**ADDENDUM
ENVIRONMENTAL IMPACT REPORT**

**NORTHBLUFF
1389TH ZONING UNIT**

**ALAMEDA COUNTY PLANNING DEPARTMENT
MAY 4, 1982**

ENVIRONMENTAL IMPACT REPORT **VOLUME II**

**FIGURE A:
EXISTING TRANSIT SERVICE
NORTHBLUFF DEVELOPMENT**

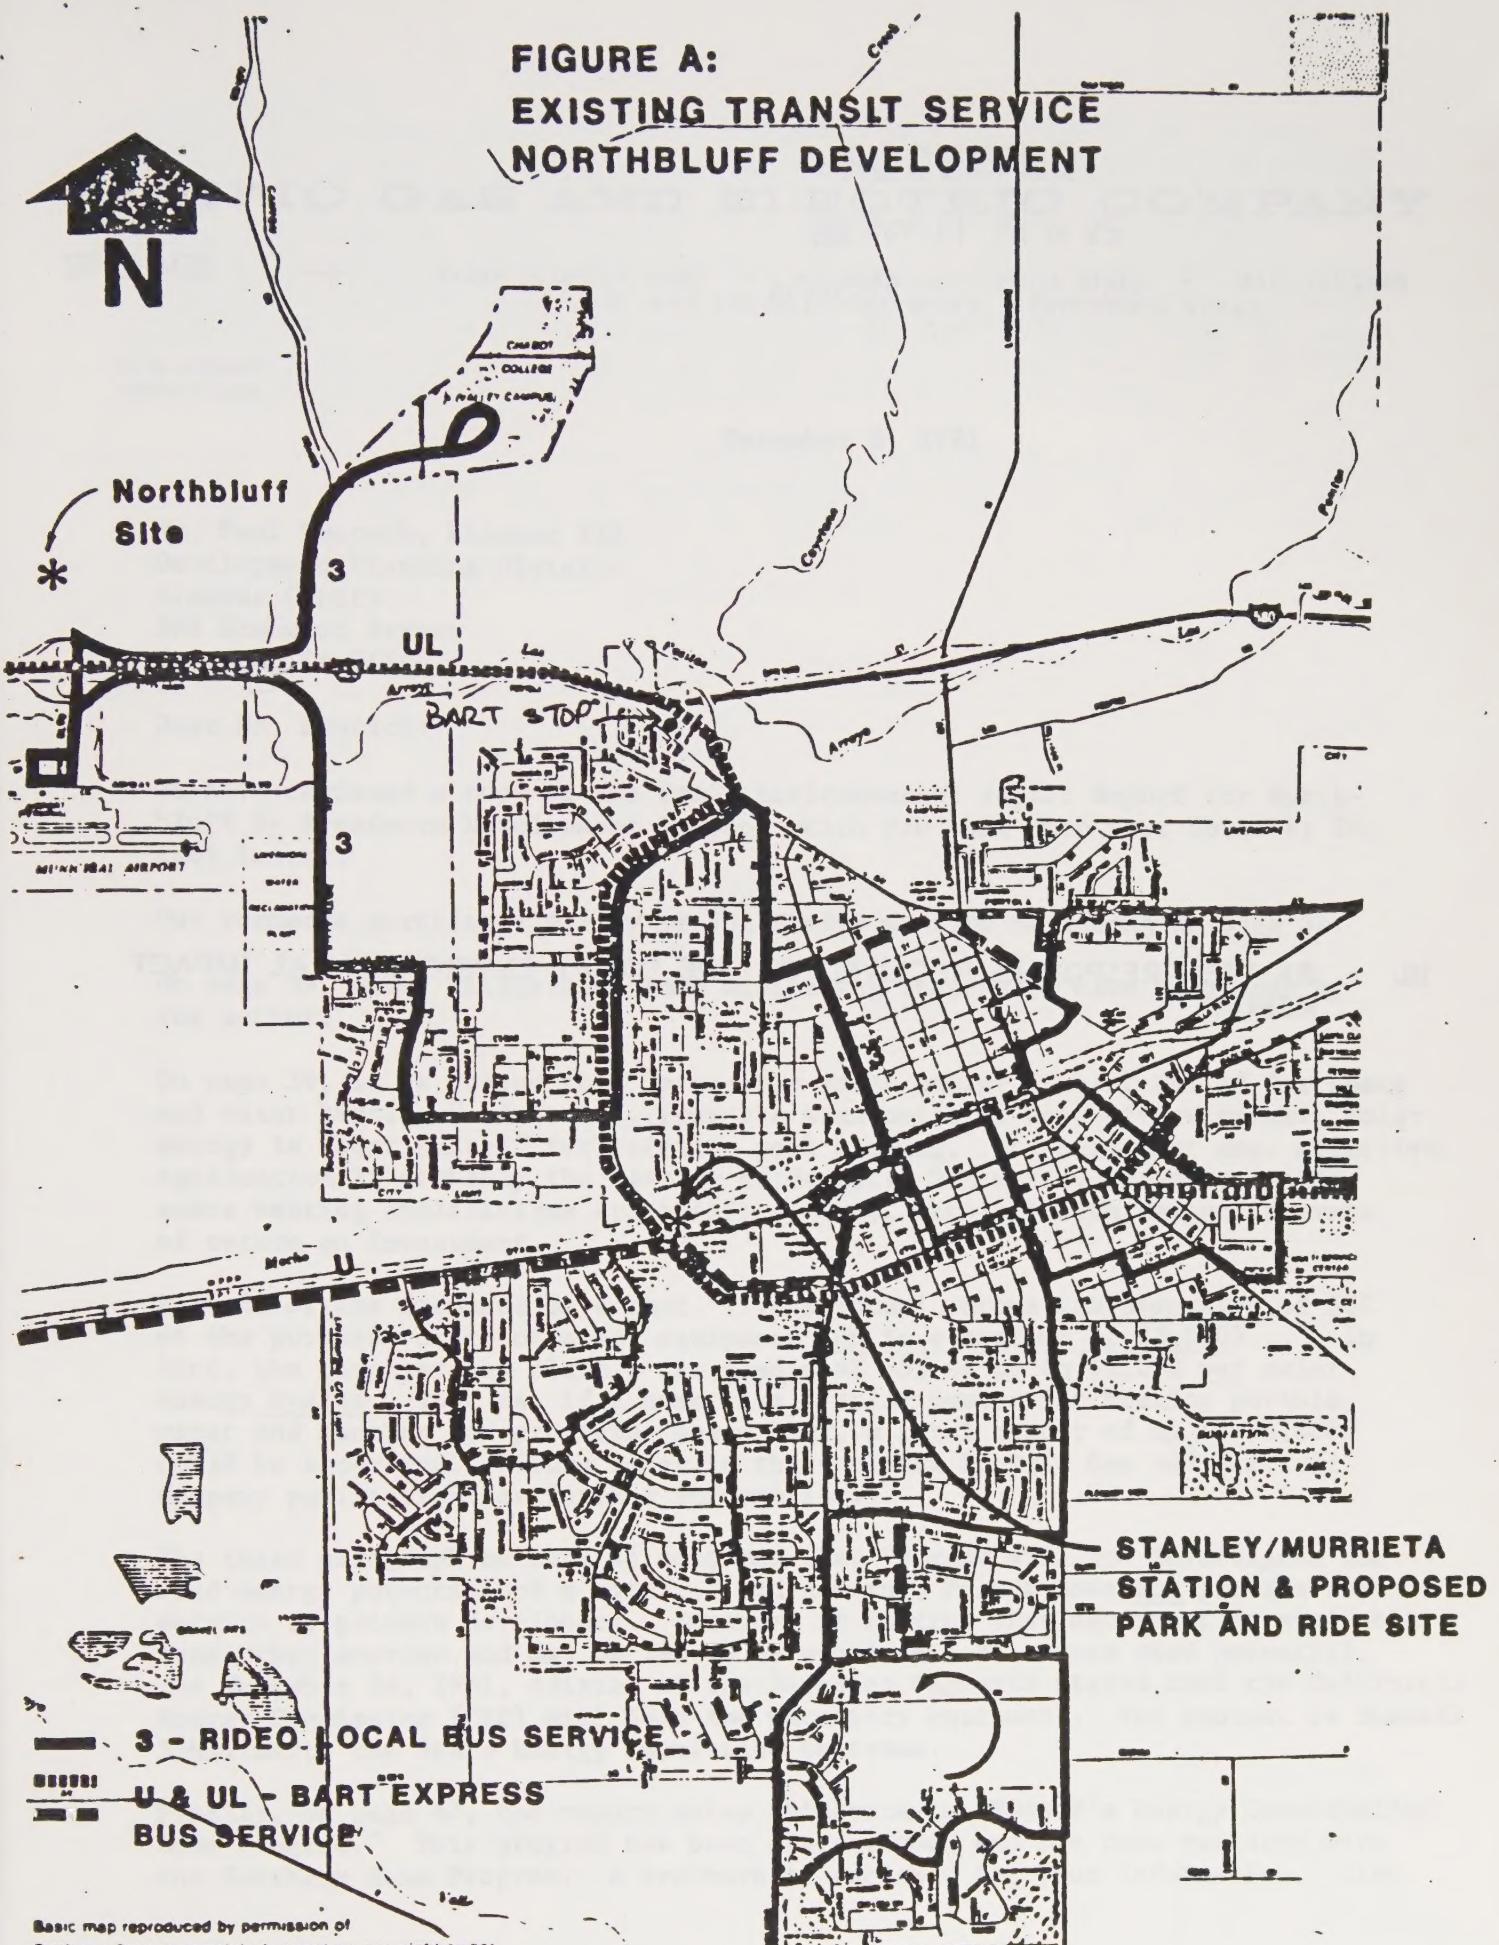
The existing transit service in the area consists of the BART Express Bus lines and the Local RIDEO bus program. The routes of both these services with relation to the Northbluff site are shown in Figure A.

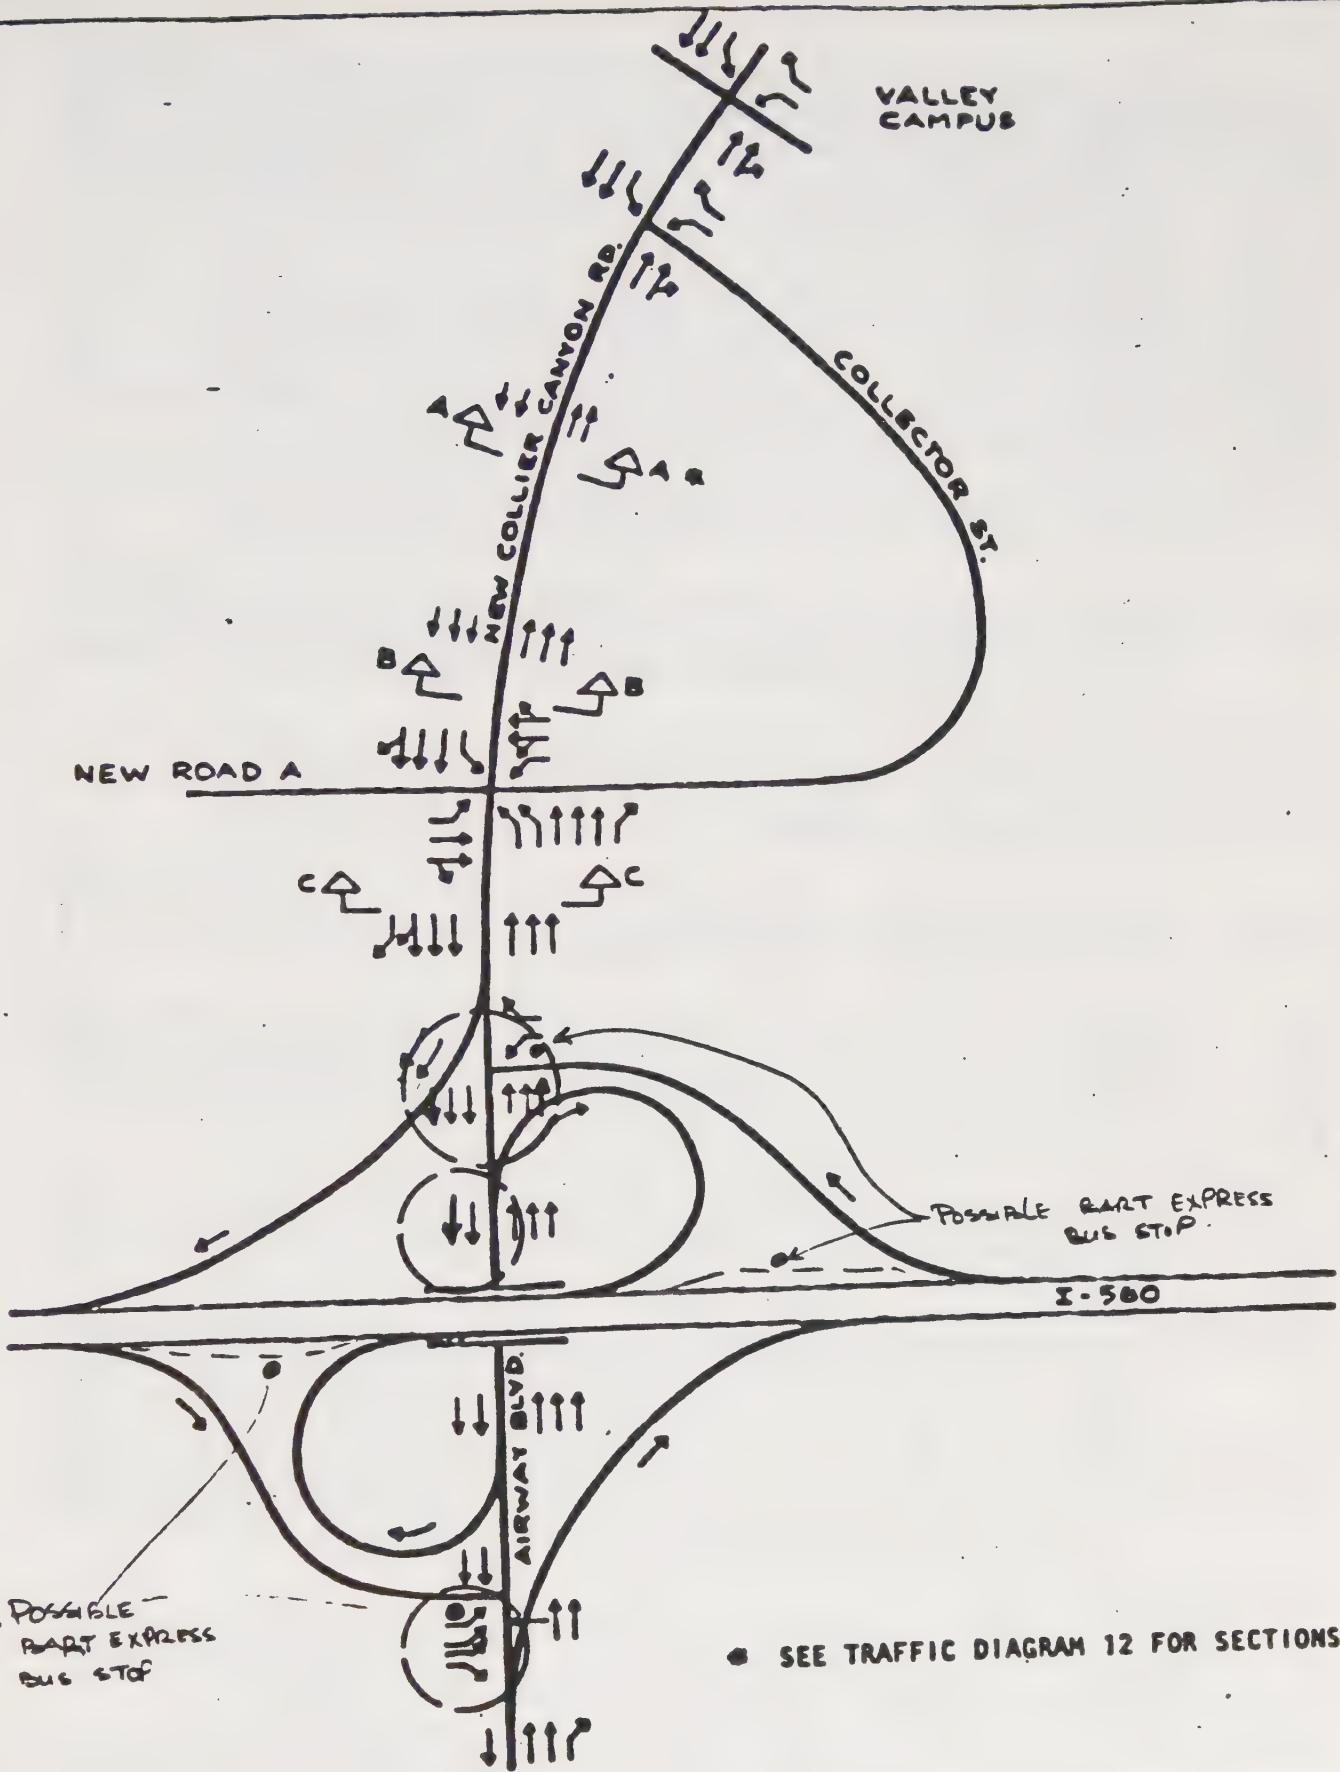
"Traffic Diagrams #10 and #11: There are not enough lanes to handle the PM peak-hour volumes. The eastbound off-ramp should have a triple left turn instead of a double left. The northbound Airway Boulevard approach to the off-ramp and Airway Boulevard intersections should have three through lanes instead of two shown."

Comment: Three left turn lanes will be provided at the eastbound I-580 off-ramp and three northbound through lanes on Airway Boulevard will be provided. See revised Traffic Diagram 10.
